1A & 1B VALLEY ROAD
59 - 63 TRAFALGAR AVENUE
LINDFIELD

SSD APPLICATION - DESIGN REPORT

APPENDIX AP6. RTS RFI RESPONSE

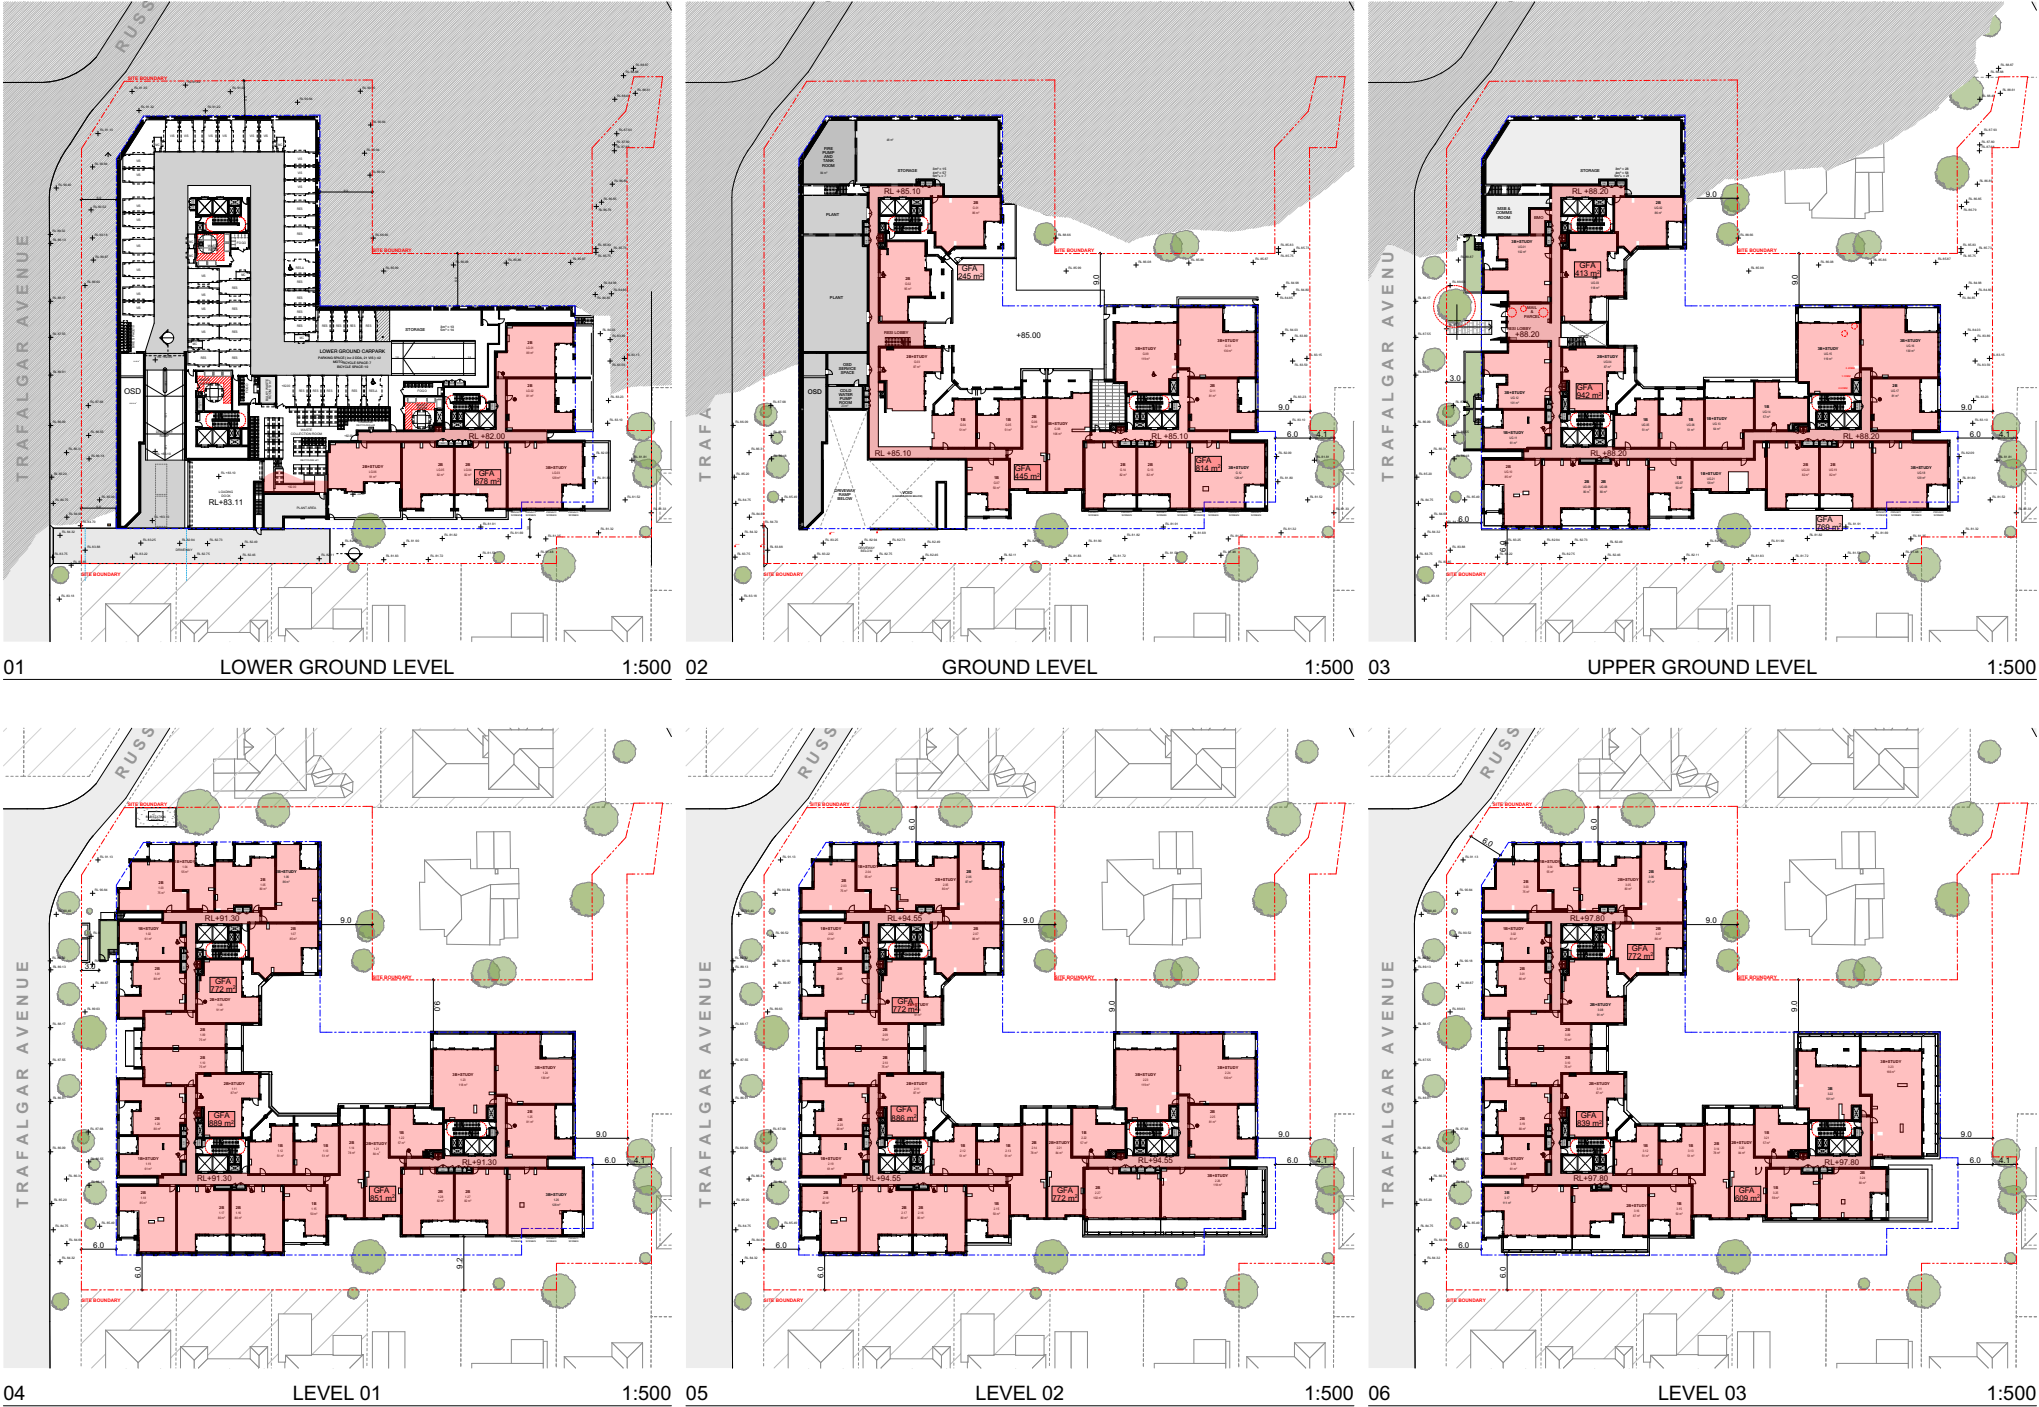
25 - f. confirm the proposed gross floor area has been calculated in line with the definition under the Ku-ring-gai Local Environmental Plan 2015

The gross floor area has been calculated in accordance with the definition under the Ku-ring-gai Local Environmental Plan 2015. The basement area has also been defined and accounted for consistently with the relevant provisions.

Eastern Facade Section 01 - Facing 3 & 3A Valley Road

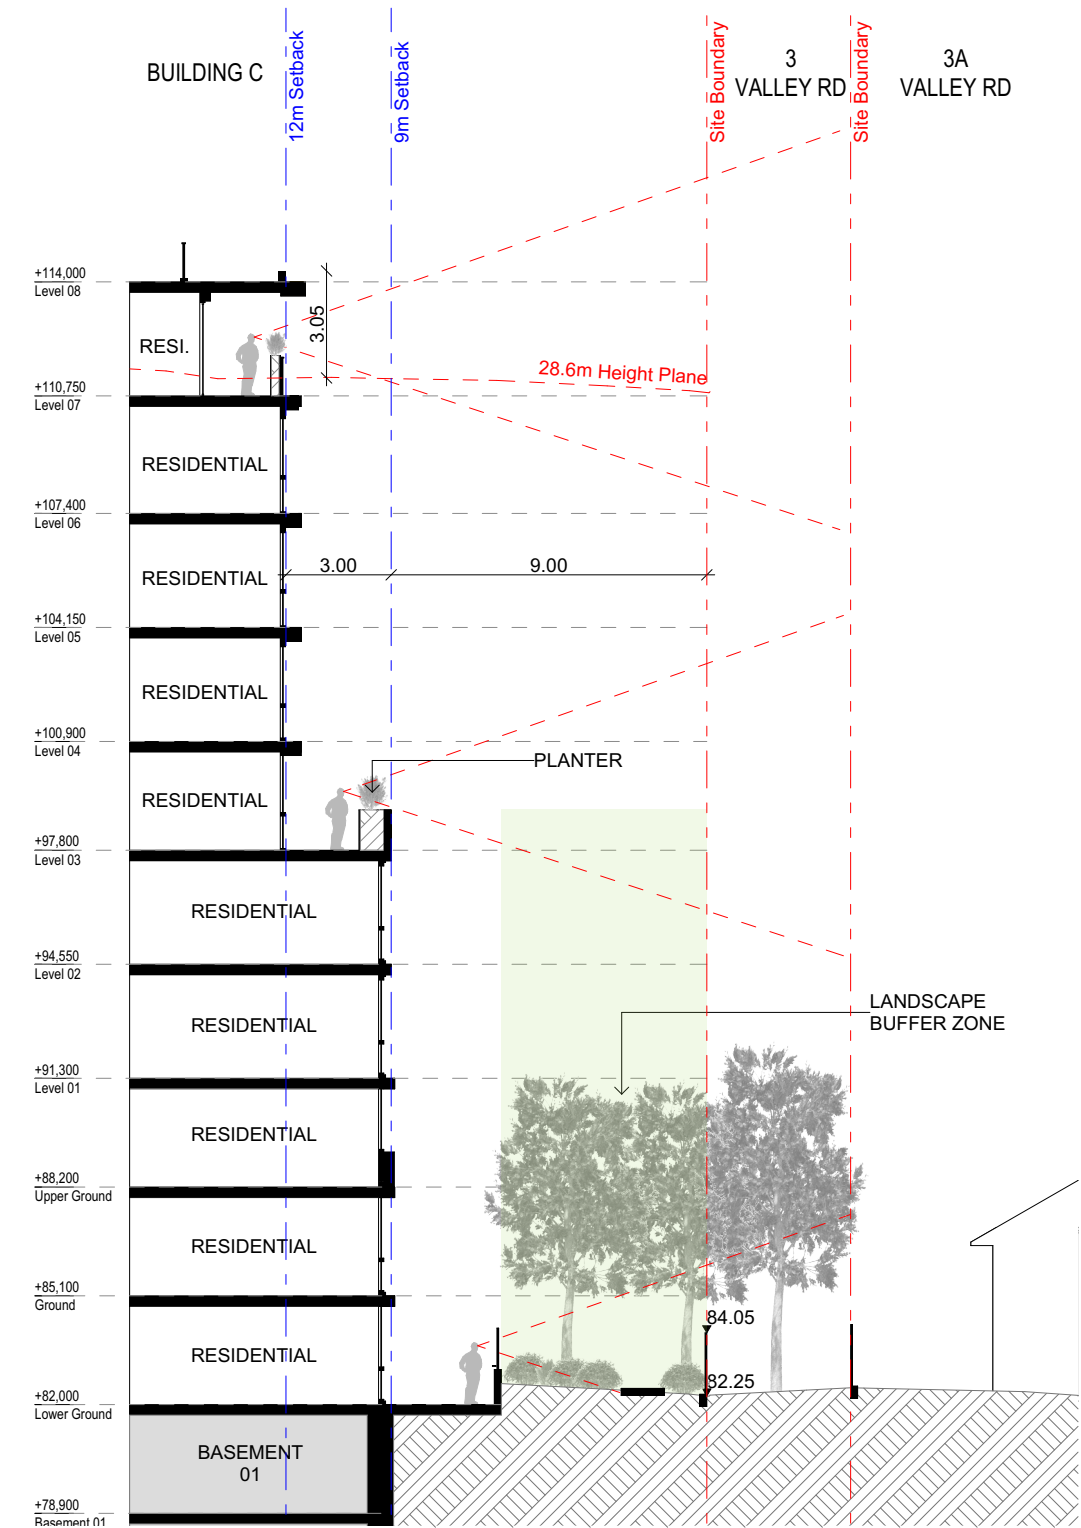
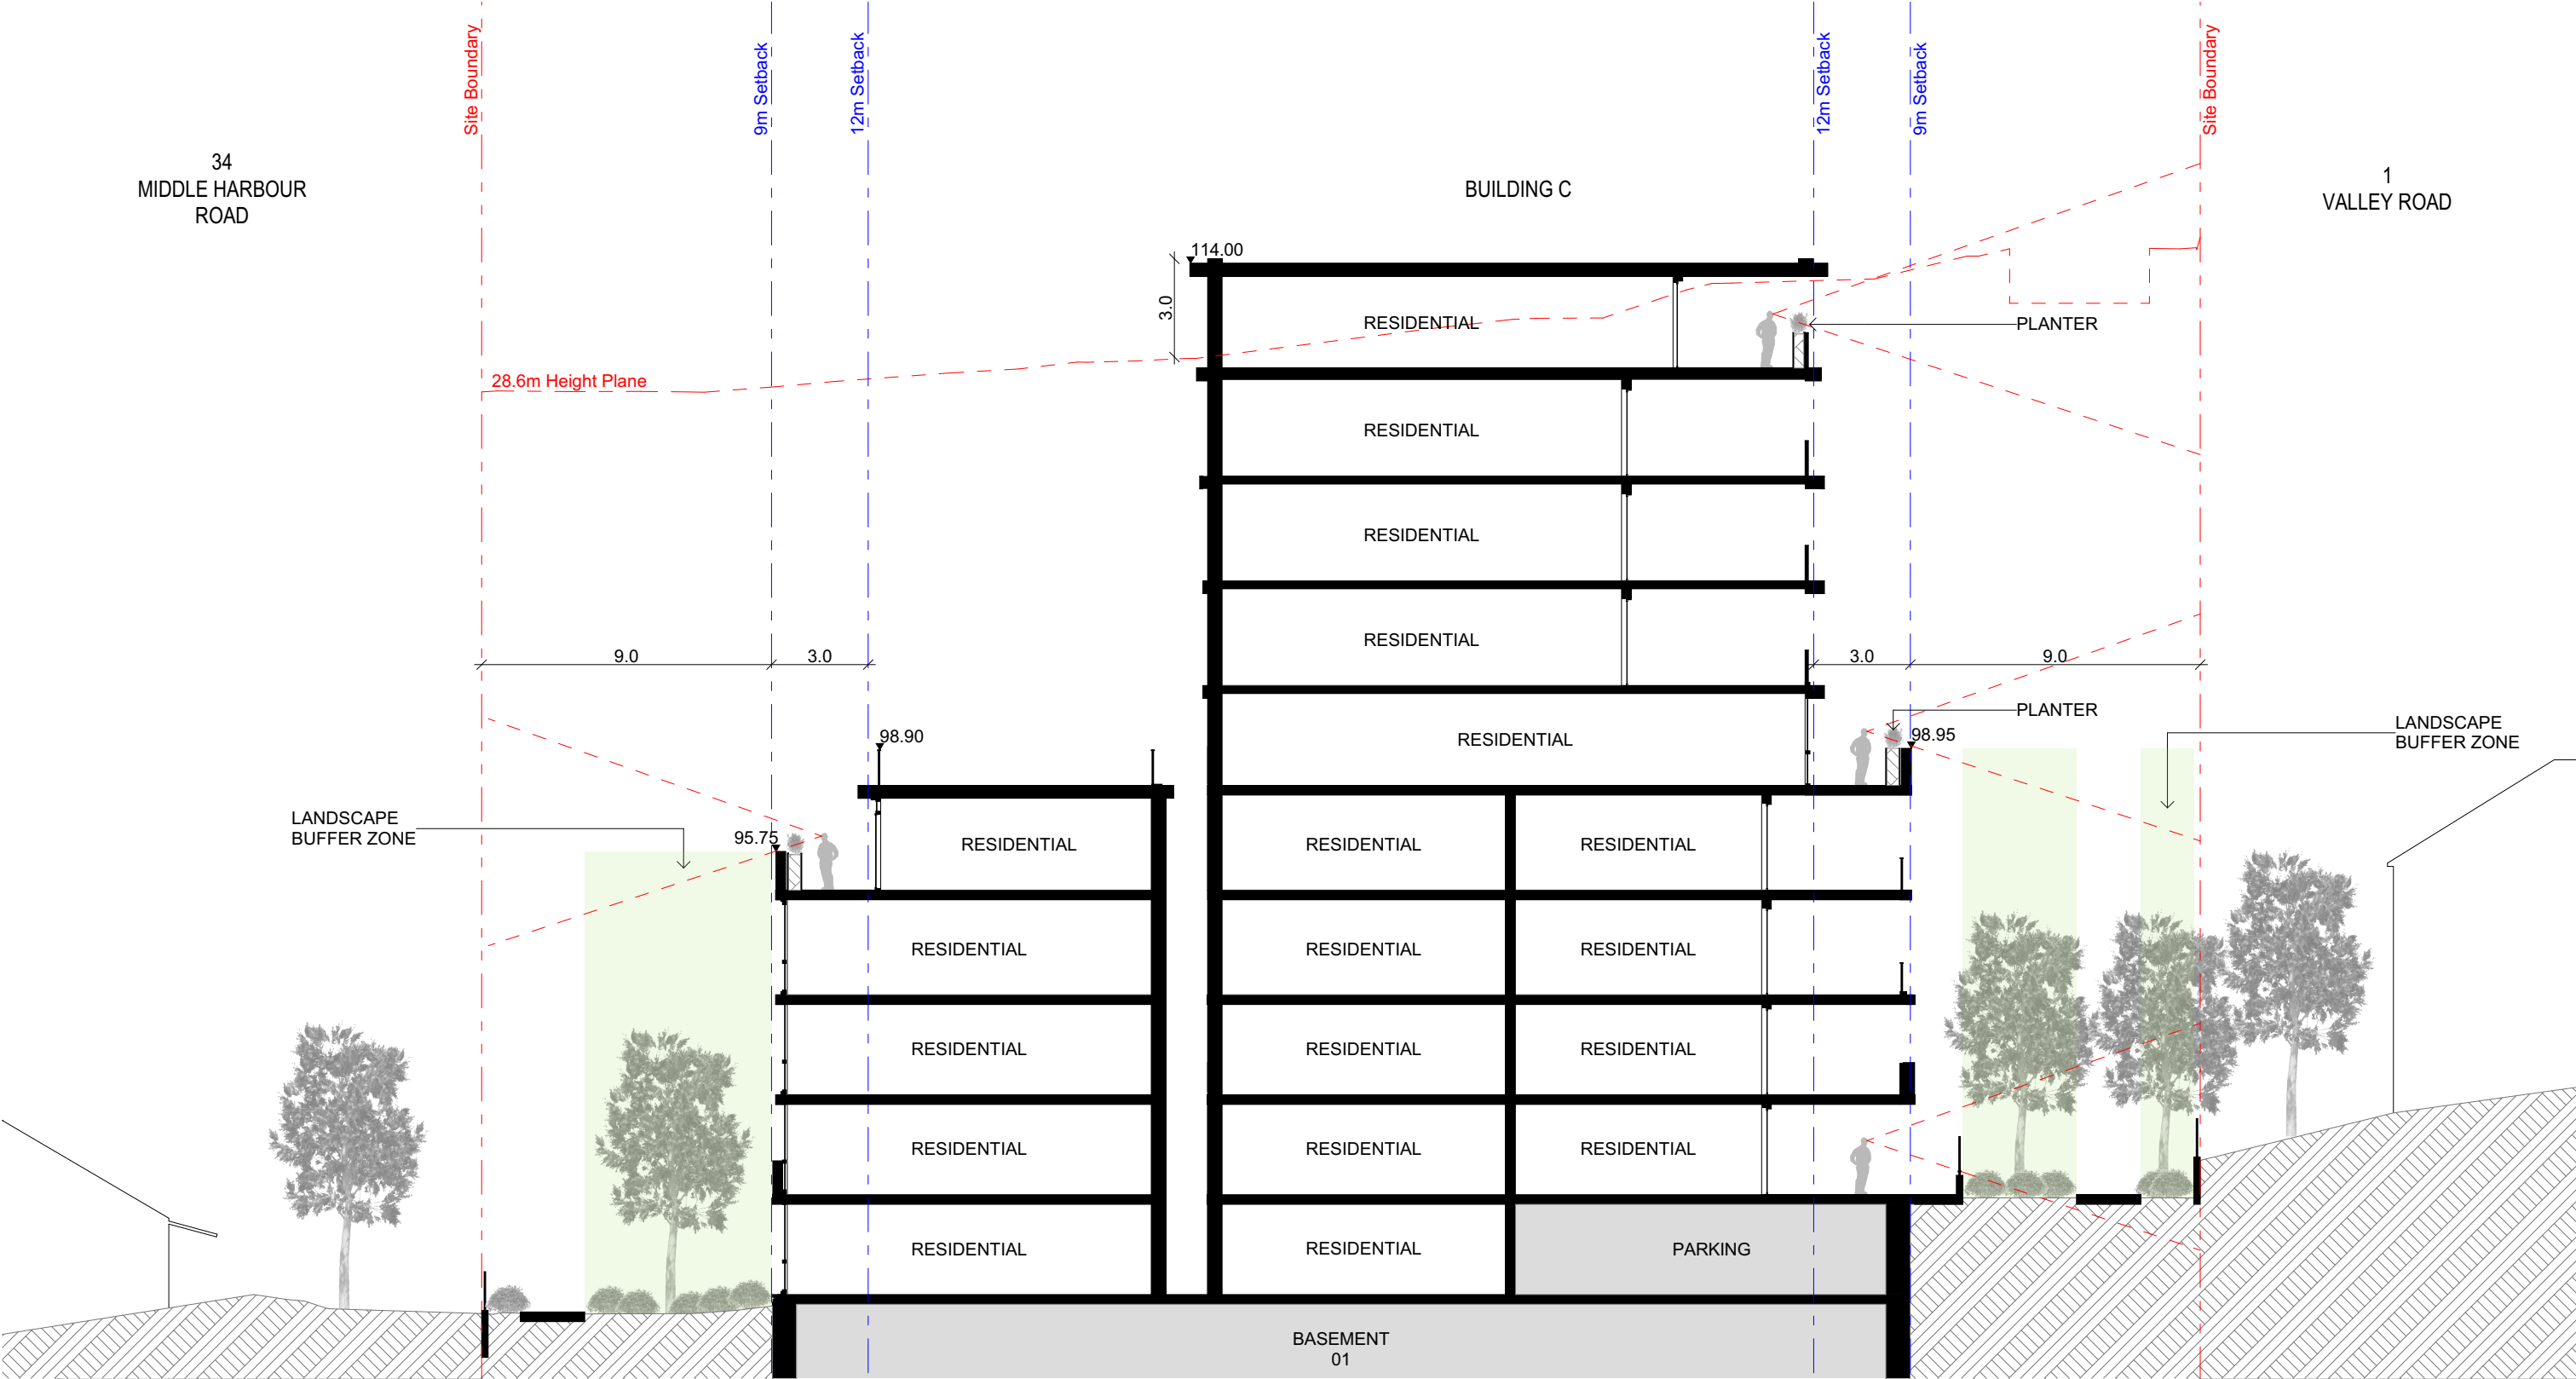
Heights to be amended to compliant heights

Level 07 on the eastern façade exhibits a building height encroachment of 3050mm, which occurs in response to the site’s steep topography. This portion of the building is carefully articulated to follow the natural slope of the land, minimising perceived bulk and scale when viewed from adjoining properties.

The architectural expression is consistently wrapped from the internal courtyard through to the eastern façade, establishing a cohesive and continuous design language across the building envelope.

Southern Facade Section 01 - Facing 30A Middle Harbour Road

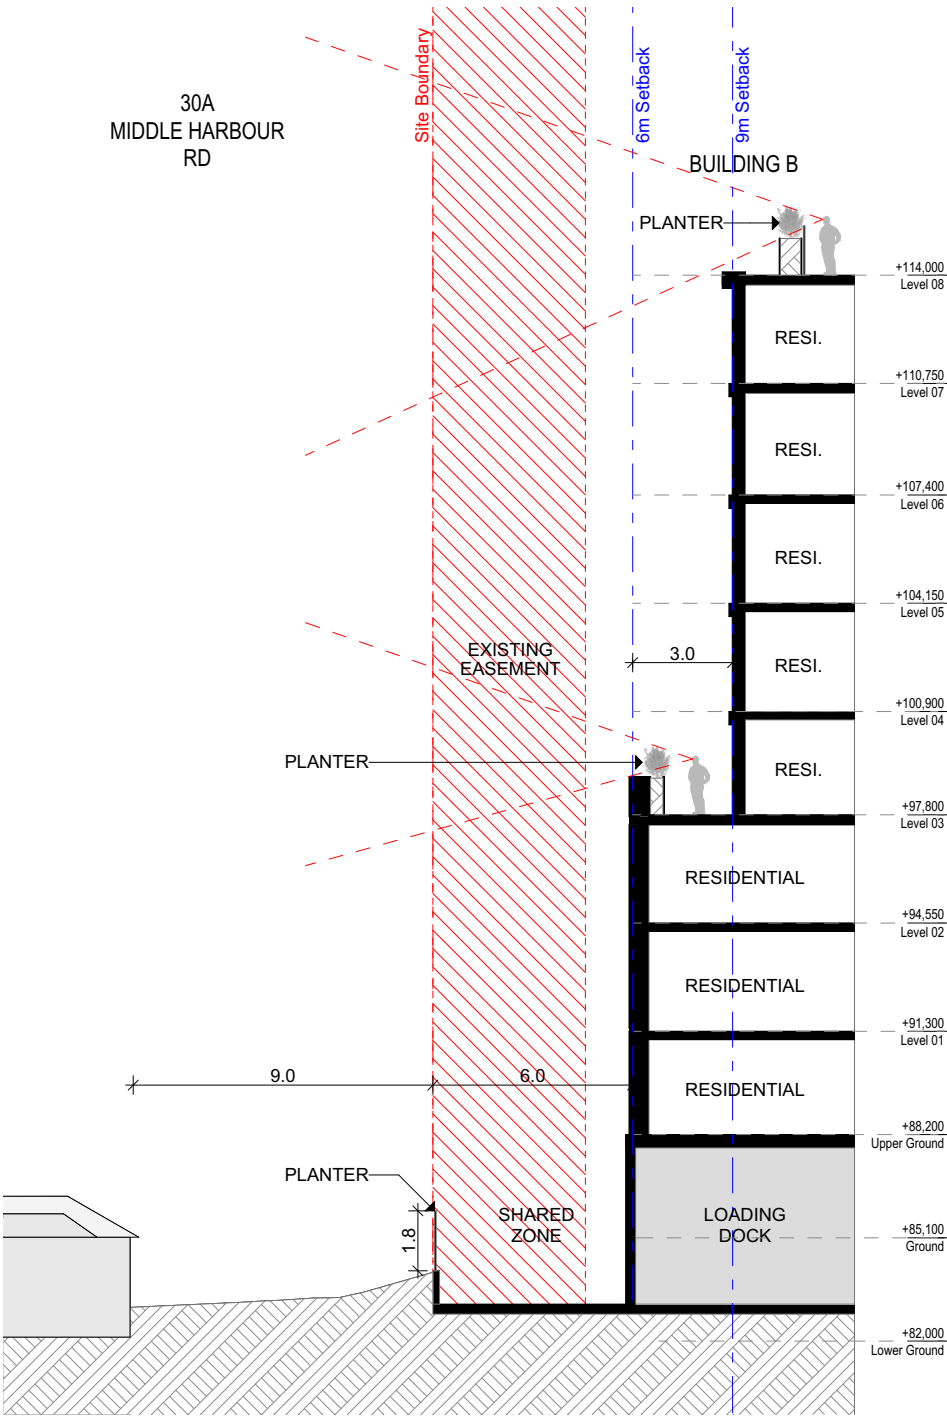
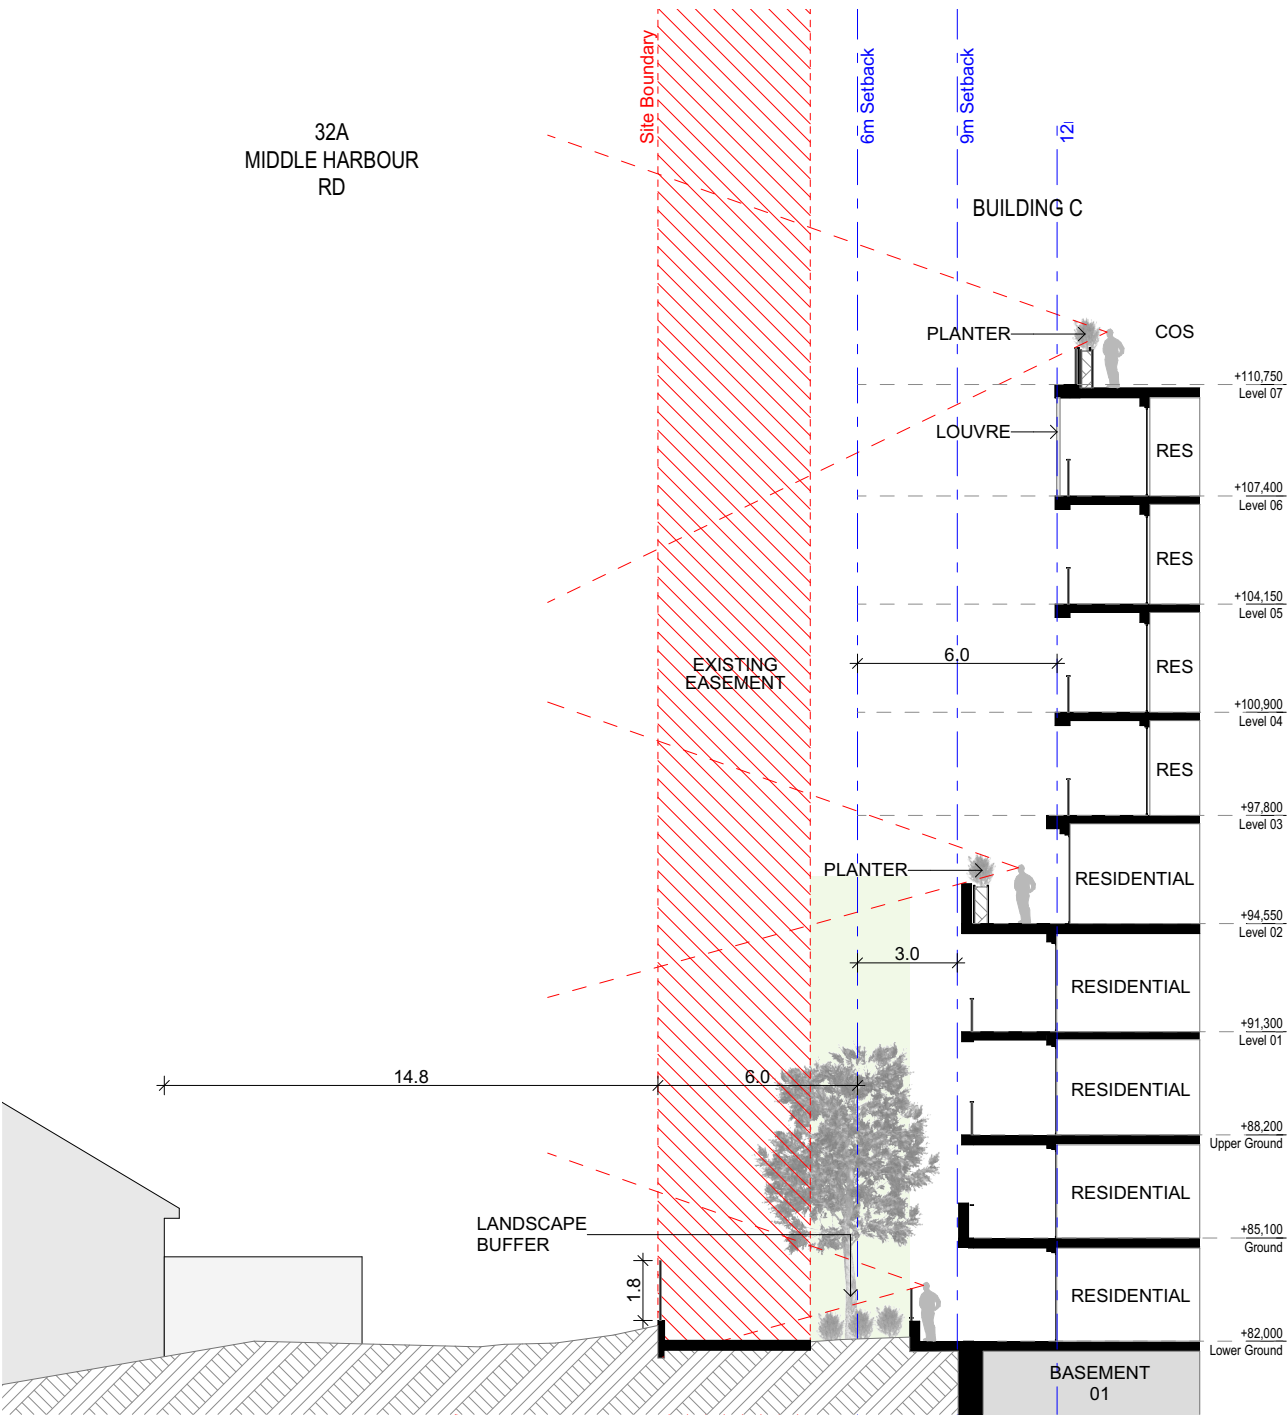
Level 5 setbacks show balcony in these zones. Justification to the ADG objective to be provided

This approach is consistent with the Apartment Design Guide objective to “ensure the privacy of residents and neighbours by limiting direct overlooking and enabling adequate visual and acoustic privacy.”
